RE: BEHS Fine Arts -Change Order 20 - Site Work - Added Asphalt and Site Electrical Work **DC**

Bullitt East High School Fine Arts
Addition
11450 KY-44, Mt Washington, KY 40047

Change Order Number: 020

BEHS Fine Arts - RFP #13 - Replace Existing Storm Structure/Curb Inlet

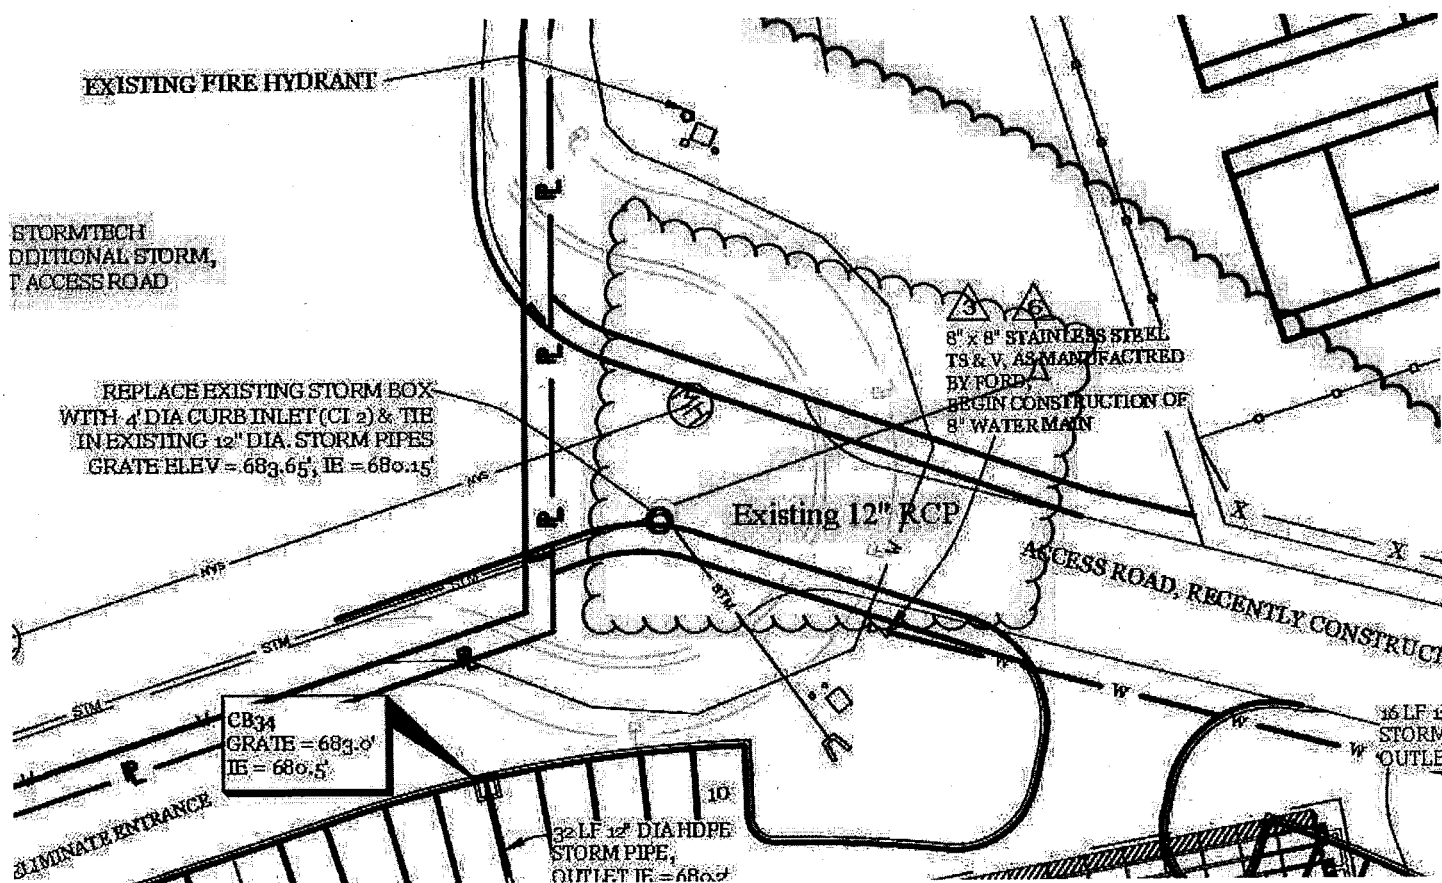
Please see attached screen shot below. There is an existing 12" RCP storm line that runs over toward the tennis courts at Bullitt East that is not shown on the RFP Drawing. If we shift the box to hit the curb line as shown, the RCP is going to be too short to reach our box and really don't even know what this line is for. It appears to be running up hill. How do you want us to address this? Can the 12" be abandoned or does it need to be extended and tied into the new box? Need to know something on this as soon as possible. Are you onsite with Calhoun today by any chance?

- COR #34 - Core Drill Structure for 12" Drain Pipe - Coring labor was required at the existing storm structure to receive an existing 12" RFP pipe that served the tennis court area. The pipe ran short of the structure when the entrance was modified.

UE1.2

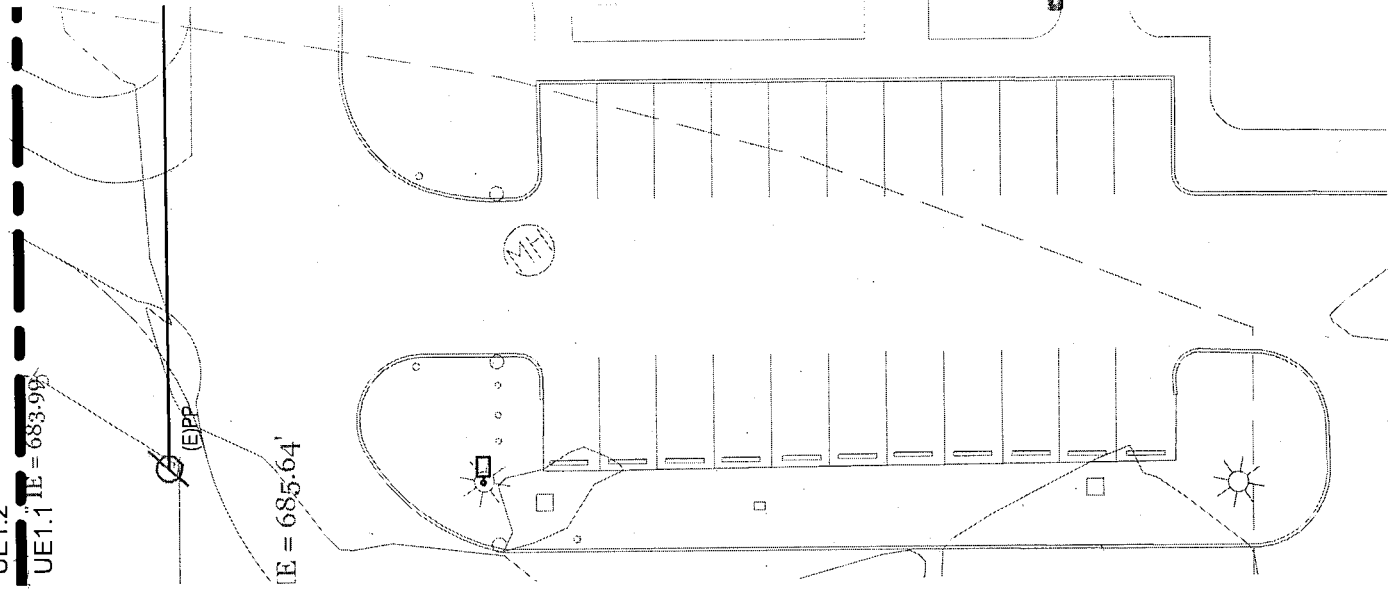
- COR #36 - Site Electrical Revisions (RFP 10) - Costs associated with primary electrical lines that need to be revised along KY Highway 44 based on Salt River Utility Requirements. What was assumed in the Bid was a shorter primary electric line since it was assumed the Utility would cross the road, however, Salt River could not provide an additional road crossing since the BEHS site is already served electrically. This resulted in the electrical contractor having to provide a longer primary electrical route.
